Kendall Banfield  
Senior Transport Planner  
Inner West Council  
PO Box 14  
Petersham NSW 2049

5<sup>th</sup> October 2021

**RE: Sydney Park Junction**

Figure 1: Plan showing the proposed changes to Sydney Park Road, King Street and Princes Highway (Source: Transport for NSW)

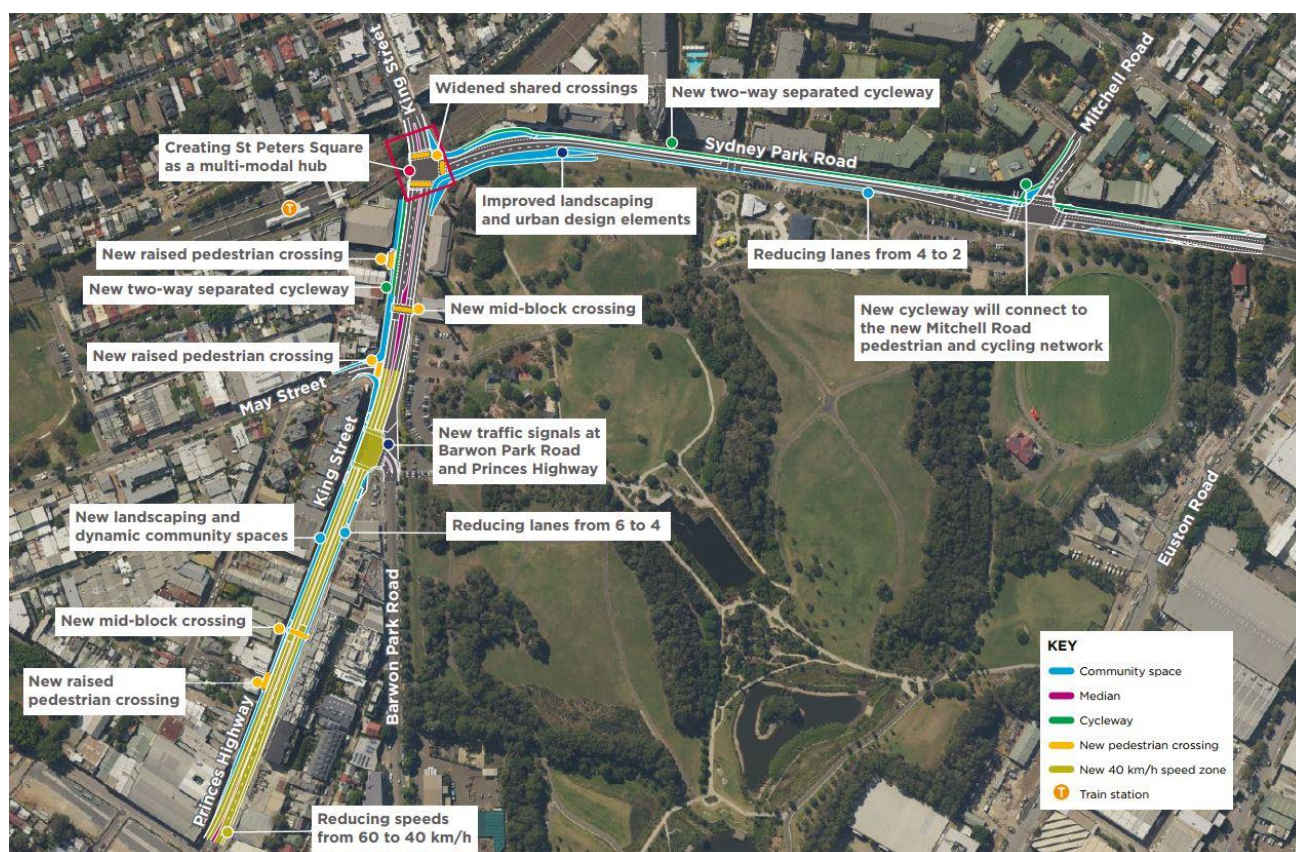
1. The separated bike lane on King Street is very short and misses opportunities to connect with the existing cycling network, particularly to the north and west.
2. Changes to access and parking may create strong opposition within the community and derail a very beneficial project. There are particular concerns about losing the right turn into May St from Princes Highway and from Mitchell Road to Sydney Park Road.

3. Vehicles may be pushed onto neighbouring streets without careful traffic management, causing increased noise and pollution and a reduction in residential amenity.
4. The Traffic and Transport Assessment (Appendix C) includes modelling of motor vehicle level of service/delay at intersections, but no modelling of pedestrian and bicycle service/delay. This is an unprofessional omission, given the objective of the project is to improve walking and cycling movement and connectivity. Unfortunately, prioritising movement for bicycles is neglected in Movement and Place Framework. However, it must be considered at Sydney Park Junction.
5. The 20-month project timeline will be hard to swallow for a community very weary from many years of disruption related to Westconnex. Night noise, diversions, temporary cycle routes and worker parking need to be resolved before construction commences.

The short section of separated cycleway proposed for King Street must extend north to allow people to cycle safely across the new St Peters Square and connect with important and well-used cycle routes heading west along Lord St to Marrickville Metro shopping area, north-west to the Enmore Road and north-east to Erskville and Newtown, Sydney University and the CBD.

Bicycle NSW wholeheartedly supports Transport for NSW's shift from 'predict and provide' to 'vision and validate' when planning neighbourhood centres. We urge you not to relent to community pressure and maintain the plan to prevent right hand turns from King Street to May Street and from Mitchell Road to Sydney Park Road. These changes are very important to restrict through traffic from local streets and eliminate rat runs. We recommend that inner West Council explores partnerships with organisations like [Cycling without Age](#) who could provide electric rickshaws to help elderly residents affected by road closures to access the shops.

- e. Eliminate the proposed traffic signals at the Barwon Park Rd/King St intersection and instead create a left in/left out intersection with a priority pedestrian/cyclist raised crossing. Traffic lights at this junction will delay pedestrians which is inconsistent with project objectives to improve walking movement and connectivity.
